CC1020 Errata Note 001, rev. 1.0

CC1020 Errata Note 002, rev. 1.0

CC1020 Errata Note 003, rev. 2.0

CC1020 Errata Note 004, rev. 1.0

Figure 1: Schematic diagram of the input/output matching network

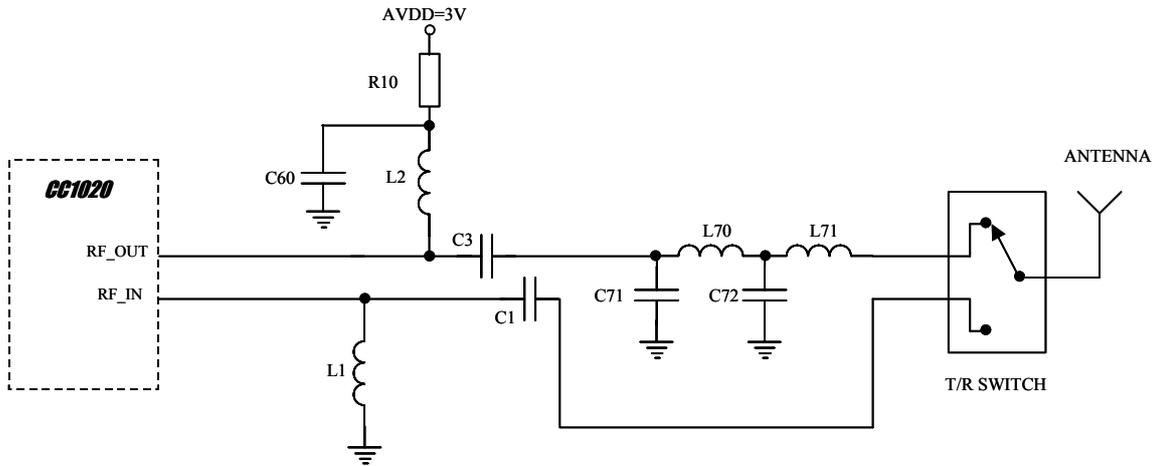
When using high output power settings with the CC1020EMX-433 v1.0 the recommended maximum voltage level on the RF_OUT pin (pin 21) is exceeded. This may cause a drop in output power over time, particularly if the transmit duty cycle is high. Power drop has only been observed on the 402 – 470 MHz version of the reference design (i.e. the CC1020EMX-433 v1.0) as the 804 – 940 MHz version has a considerably lower voltage swing during transmit.

For the CC1020EMX-433 v1.0 operating at 3.0 V, 402 – 470 MHz, with an output power of +10 dBm, the output power has been observed to drop by more than 3 dB over weeks with continuous transmit operation. The majority of the power drop occurs during the first hours. For operation above 3.0 V the drop can be slightly worse, while for supply voltages lower than 3.0 V, the drop will be less.

By lowering the load impedance “seen” by the CC1020 power amplifier, the output power drop is avoided. The series resistor R10 is added to reduce the DC voltage at the RF_OUT pin. Finally, for the CC1020EMX-433 the filter topology has been changed from a π -type filter to a T-type filter in order to achieve a better combination of reflection factors for the harmonics. This change applies to the 433 MHz frequency only. Altogether, these changes, which are implemented in the new CC1020EMX reference design v2.0, remedy the output power drop problem. The new solution increases the current consumption in transmit mode by typically 3 mA at maximum output power.

For future designs, Chipcon recommends using the most recent CC1020EMX reference design (v2.0 or higher), which is available on web at www.chipcon.com. The matching components for this reference design are shown in *Figure 1*. For 804 – 940 MHz, no changes to legacy v1.0 based designs are necessary. However, the resistor R10, as shown in *Figure 1*, will be included in all future CC1020EMX reference designs (please note that from v2.0 there is one common PCB design supporting all of the 433/868/915 MHz frequency bands).

Copy the CC1020EMX reference design v1.1 (4-layer), v2.0 (2-layer) or newer.

A schematic diagram of the input/output matching networks for the CC1020EMX reference design v2.0 is shown in *Figure 1*.

Figure 1: Recommended PLL calibration procedure

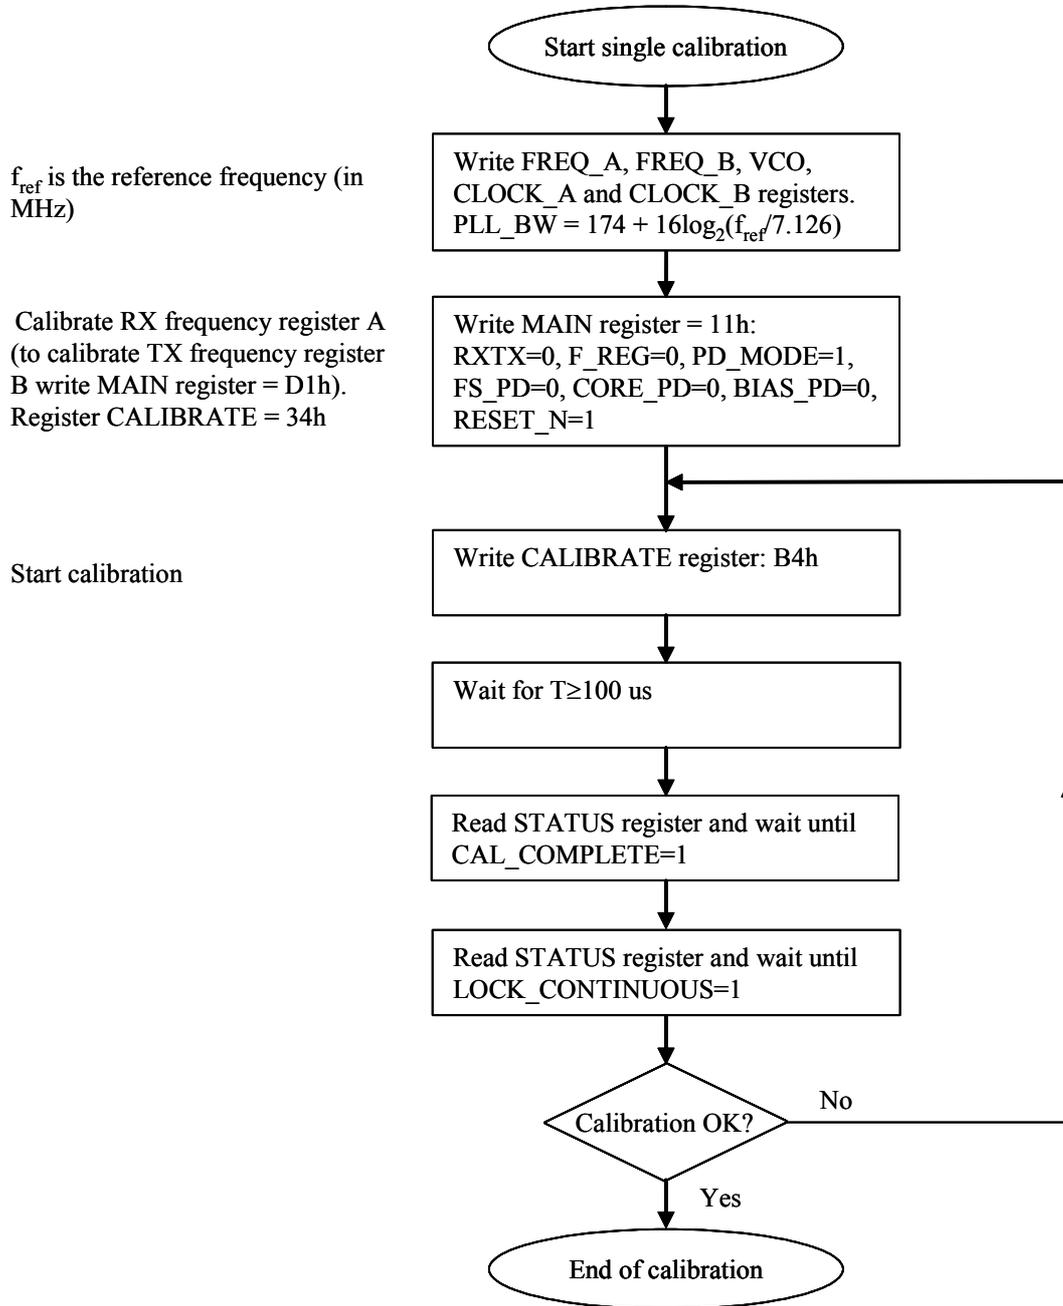
When using a 14.7456 MHz crystal frequency the CC1020 calibration (monitored by steps 2 and 3) typically lasts 27 ms. However, it has been observed that the CAL_COMPLETE indicator in the STATUS register is unreliable during the first 100 μ s after initiating the calibration. As a result step 2 might indicate calibration complete too early, i.e. before the actual calibration has actually completed. In such a situation step 3 (LOCK monitoring) is executed during instead of after calibration. In order to avoid this inconsistency, a waiting period of at least 100 μ s between calibration start and the start of the polling should be applied using one of the following methods:

In less than 10 ppm of all PLL calibrations performed it was observed that CC1020 did not achieve LOCK even when introducing a 100 μ s wait period before polling of [STATUS.CAL_COMPLETE] was initiated. The reason for no LOCK still occurring, even when calibrating the PLL with this small wait period, is due to the PLL calibration procedure making an erroneous frequency measurement causing the PLL calibration algorithm to choose a wrong capacitor array setting producing a no LOCK situation. For this reason it is important to control that the PLL calibration achieves LOCK and recalibrate if it does not.

Calibration starts when CALIBRATE.CAL_START is set to 1 as shown in figure 1. The PLL is then set to open loop and the internal VCO control voltage set to a value given by CALIBRATE.CAL_ITERATE[2:0] = 4_h. Based on this value a capacitor array is selected and when the calibration is completed the PLL loop is closed.

For those users who have not already implemented a recalibration procedure in software it is strongly recommended to avoid polling [STATUS.CAL_COMPLETE] until 100 μ s has elapsed following calibration start, then monitor LOCK after calibration complete and, if LOCK is not achieved, recalibrate until LOCK is successfully achieved. The recommended calibration procedure, including recalibration, is provided in figure 1.
